# West Oakland Link Initial Study/ Mitigated Negative Declaration Addendum

**NOVEMBER 2024**

### 1.3 Proposed Revised Project

Figure 1-8a

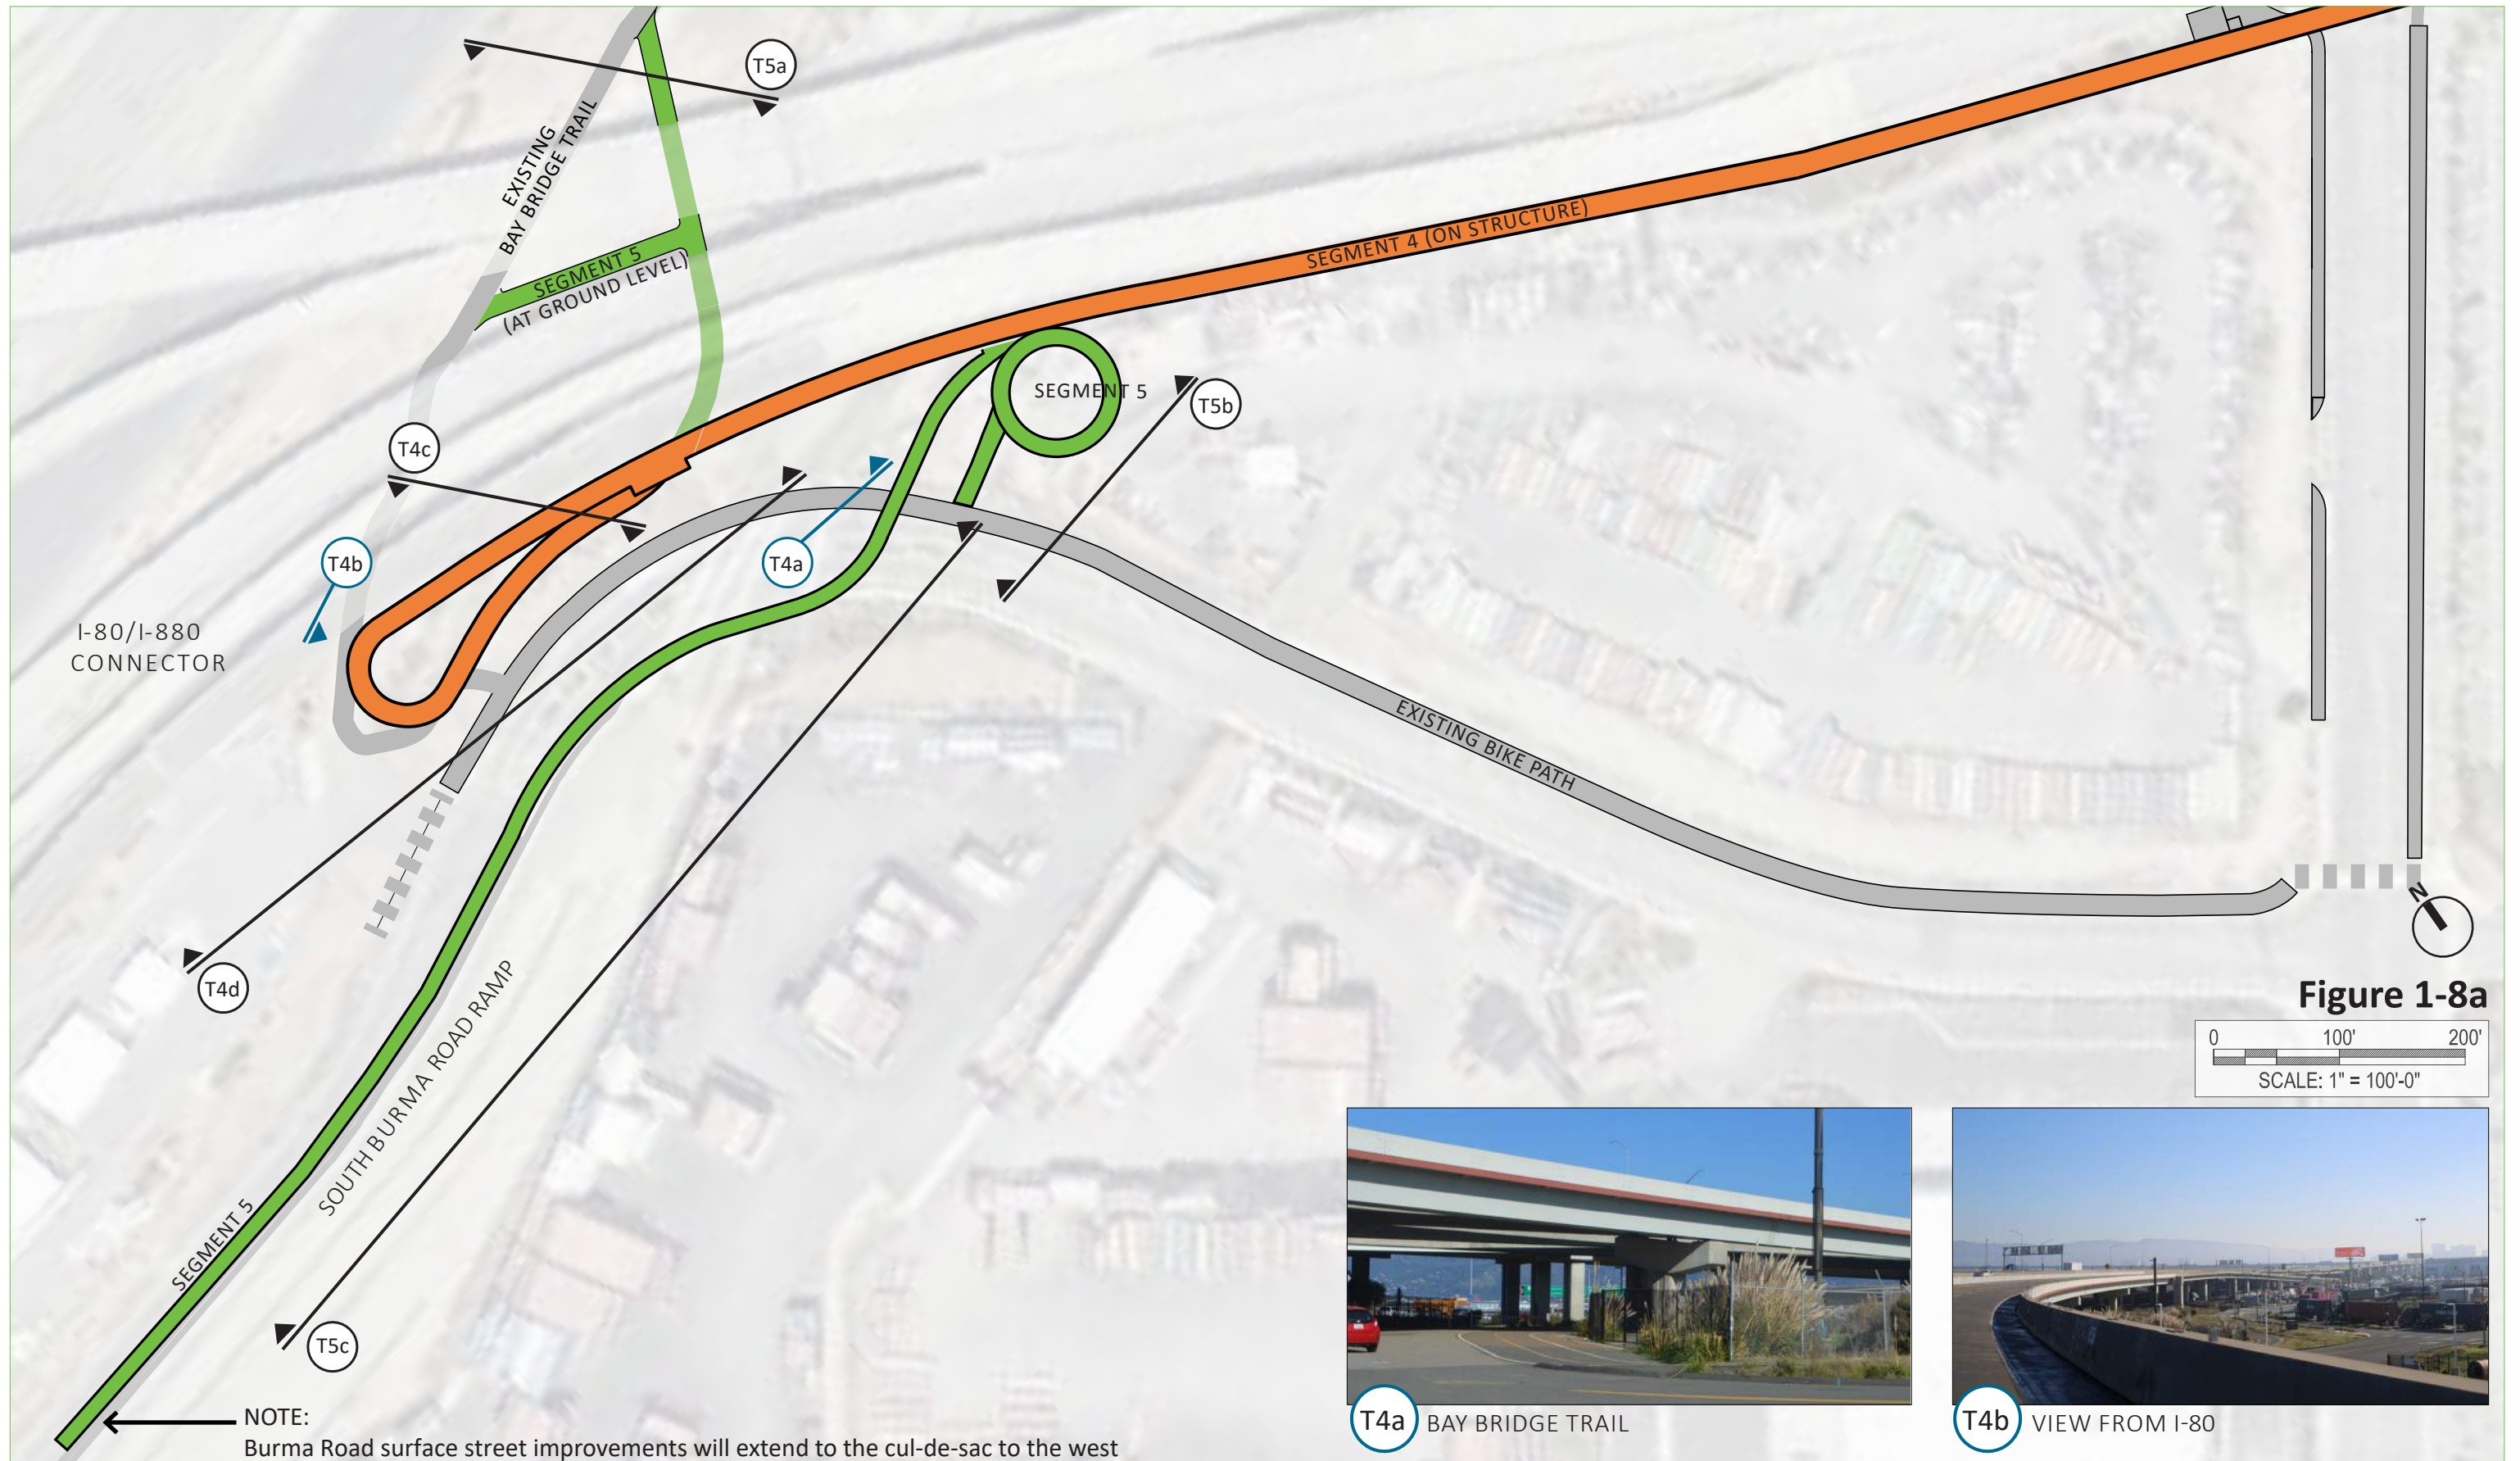
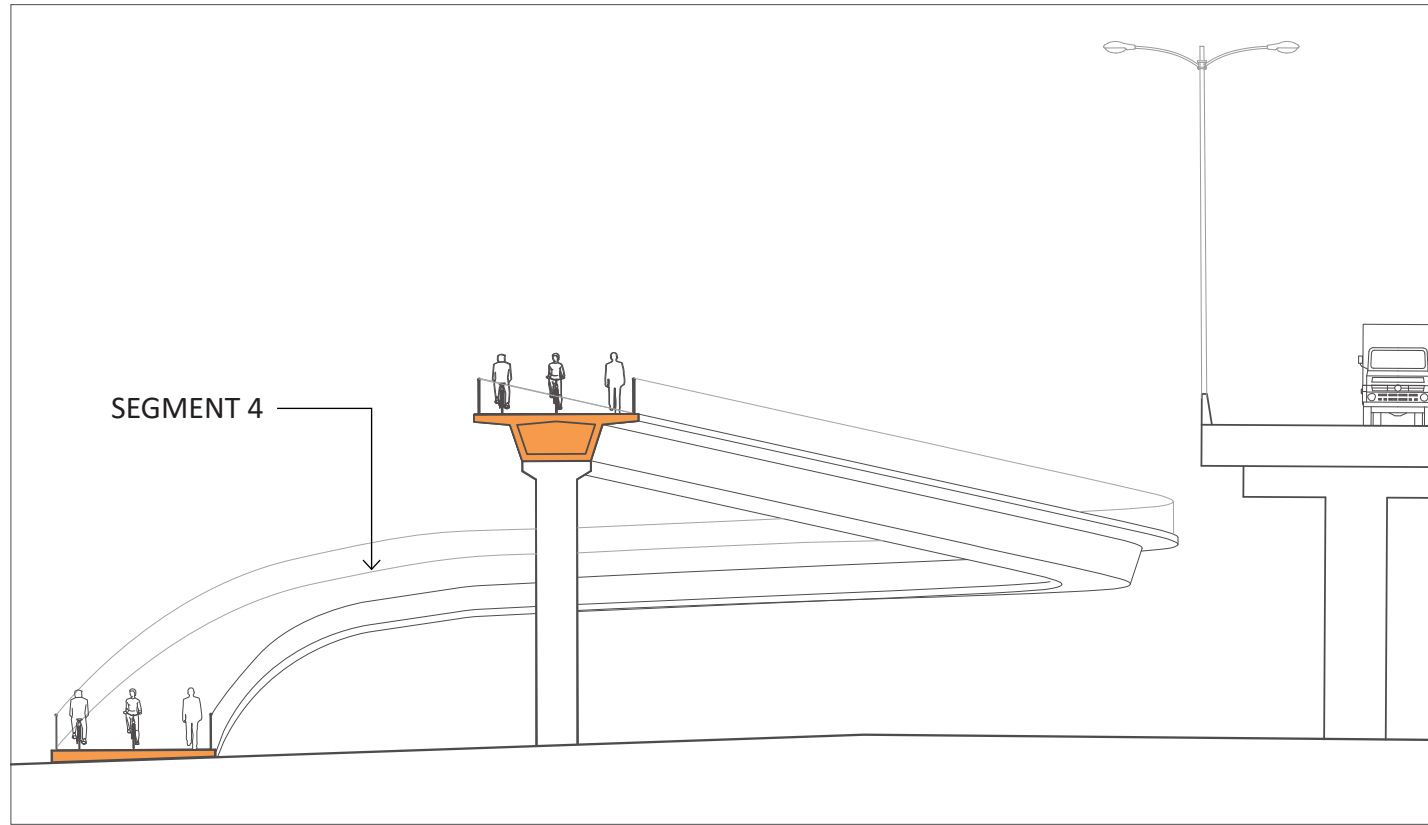
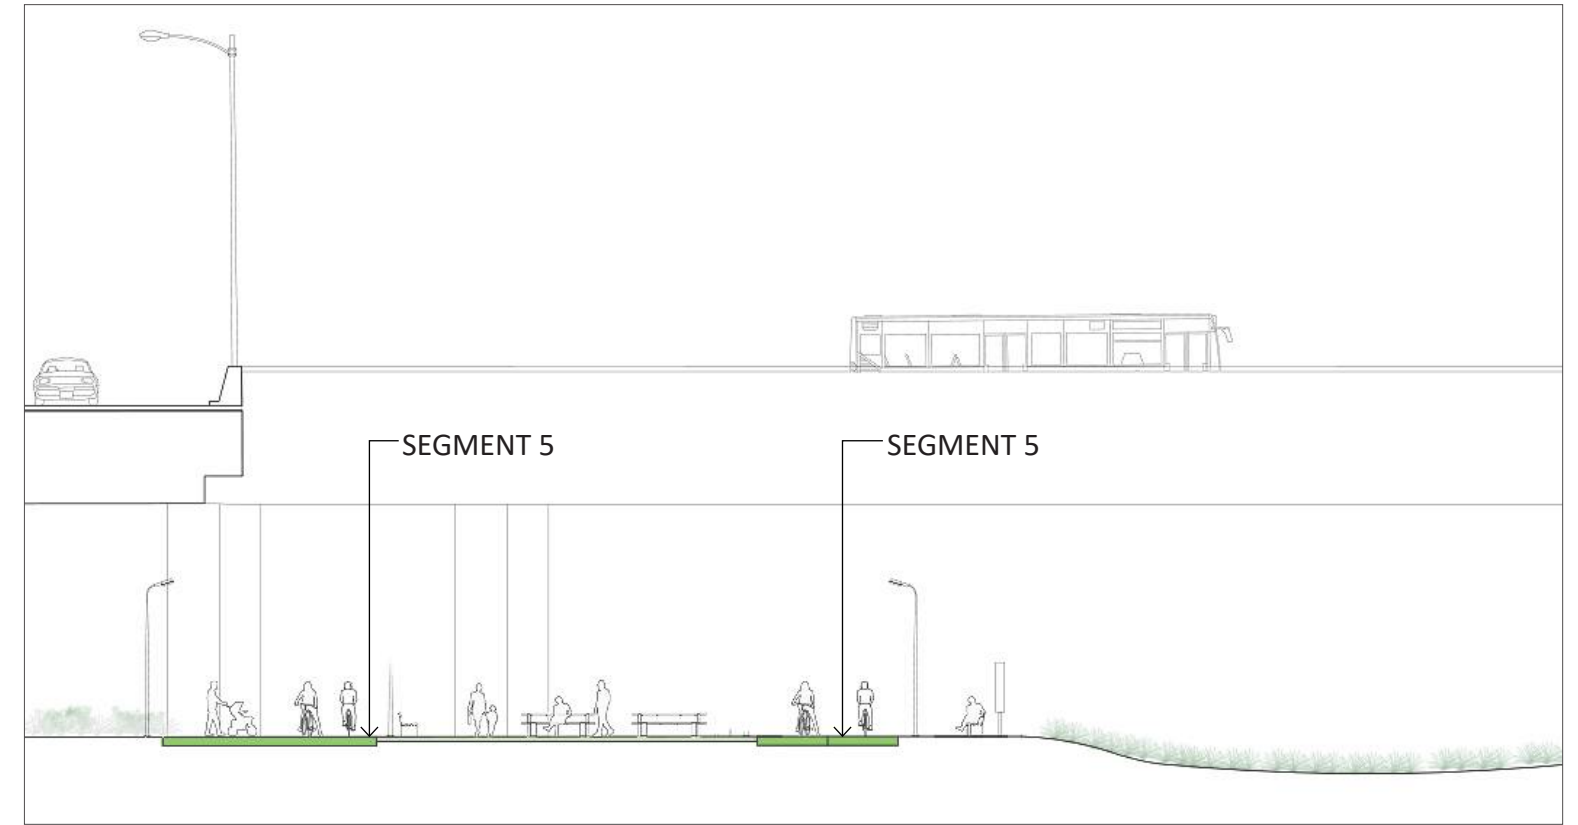
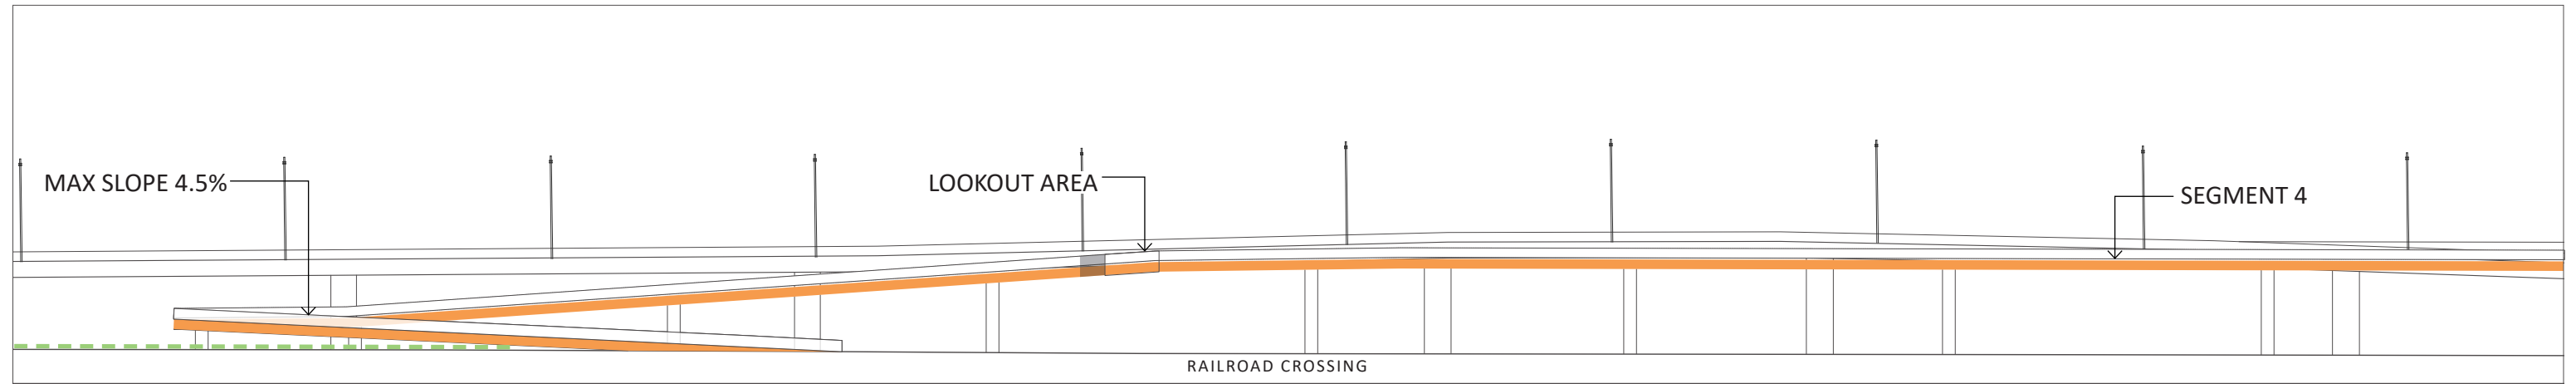
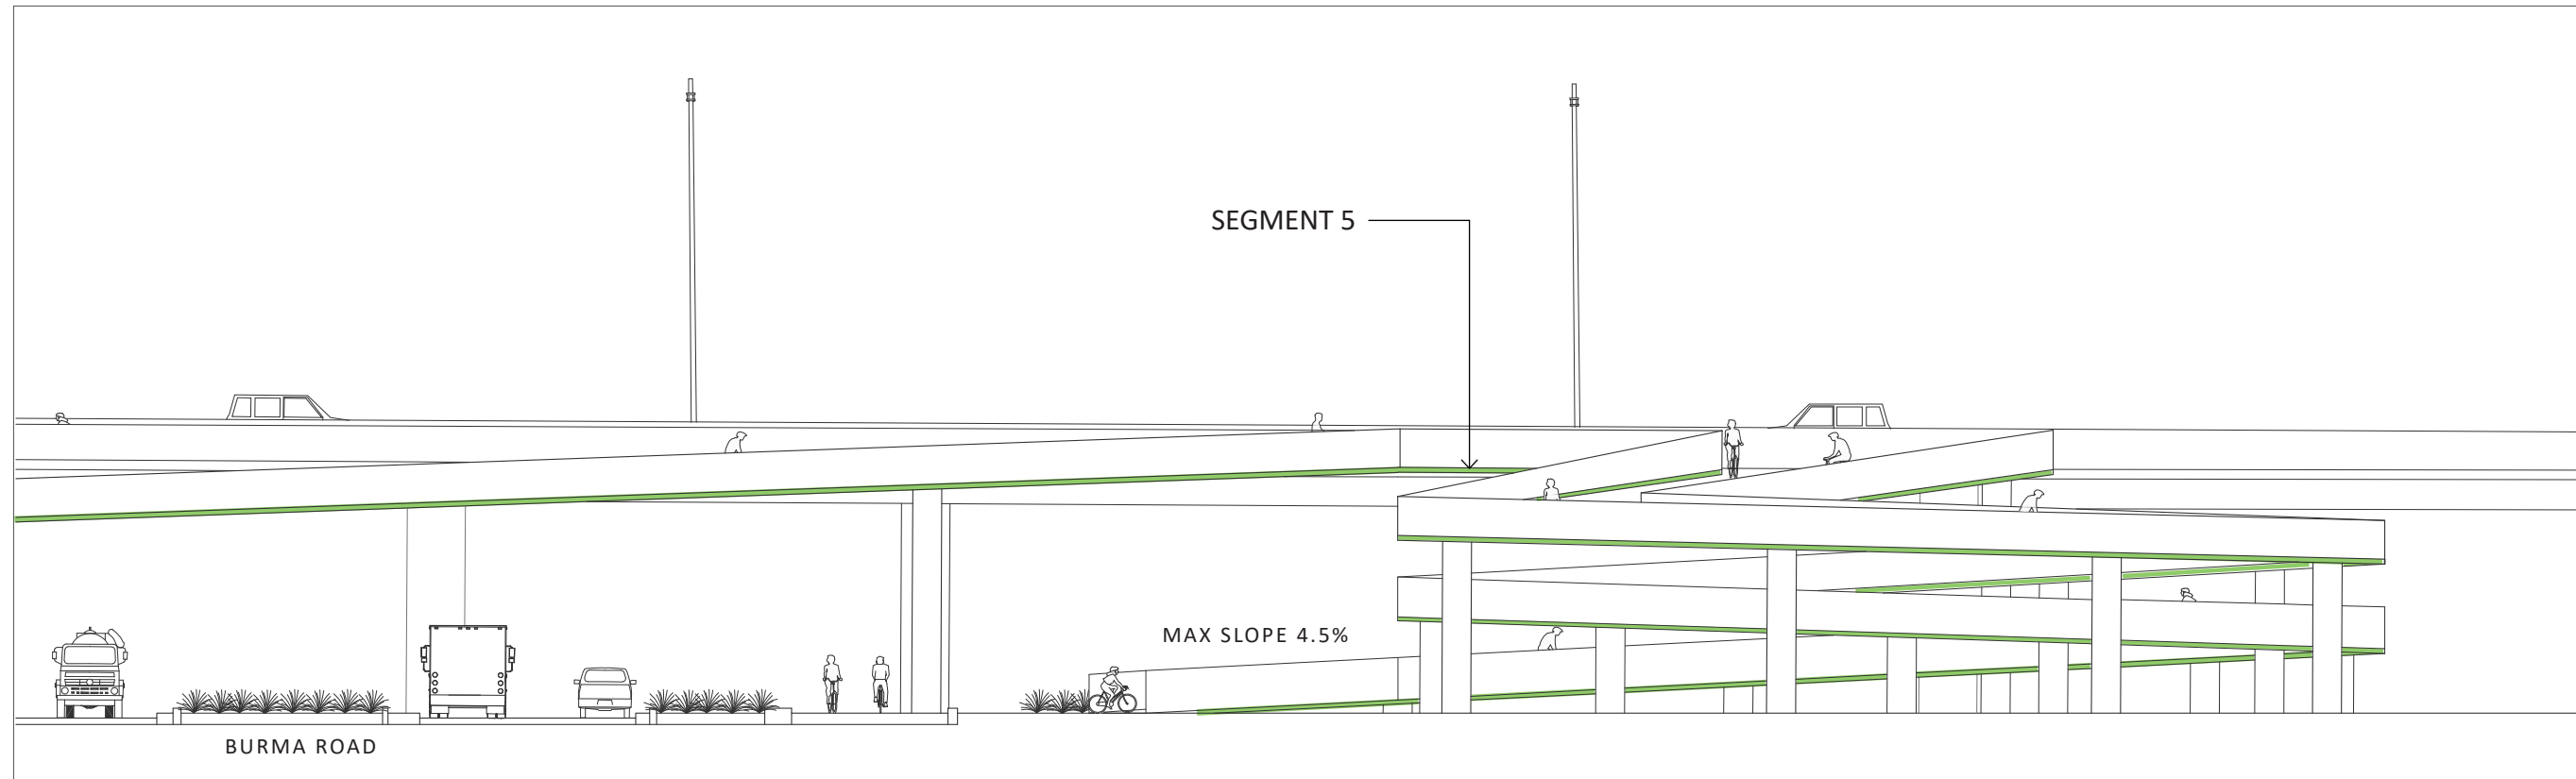
Segment 5 of the Proposed Revised Project, as shown in Figures 1-8a, 1-8b, and 1-8c, would have a slightly different configuration and continue for 200 feet at grade before connecting to the Bay Bridge Trail north of the I-80/I-880 connector. Segment 5 would include a seating area that would be located at grade, providing a bench and shade. This would be set back from the path but within overall pathway area. In addition, Segment 5 would include other ramps to access the Bay Bridge Trail that were not discussed in the Adopted IS/MND:
